RE: Drainage Conformance Letter
Lot 4, the Shops Filing 1 at Meridian Ranch

The attached short form drainage report is to serve as a statement of compliance for the development of Lot 4 of the Shops Filing 1 at Meridian Ranch commercial property with the *Preliminary/Final Drainage Report for Meridian Ranch Filing 4B, The Shops at Meridian Ranch* (the REPORT) prepared by Tech Contractors, dated April 2014, and approved on September 9, 2014. The REPORT provides hydrologic and hydraulic analysis for the development located at the northeast corner of Meridian Road and Stapleton Drive in El Paso County, Colorado.

Scale		AS SHOWN		DRI	
Drawn by	TAK	Checked by	RG	Date	JUNE 2018
Sheet Number	DRI				
LOT 4 - THE SHOPS FILING 1 FINAL DRAINAGE PLAN FIGURE X					
MERIDIAN RANCH					
TECH CONSTRUCTION CORP. 10305 ANGELES ROAD PEYTON, CO 80831 TELEPHONE: 719.495.7444 FAX: 719.495.7608					
No.	Revisions	Date	Init.	Appr.	Date
-	-	-	-	-	-

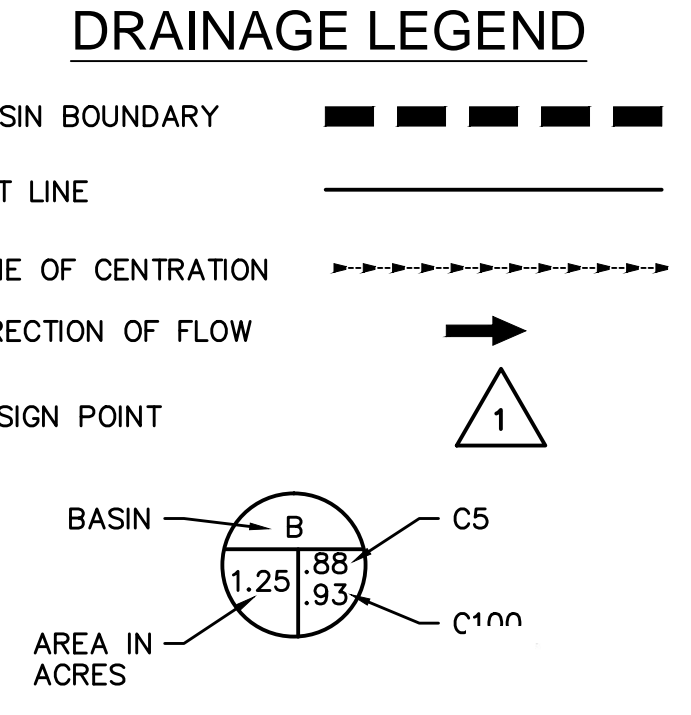
Identify what this document is
 Show where the proposed SNOOT is located
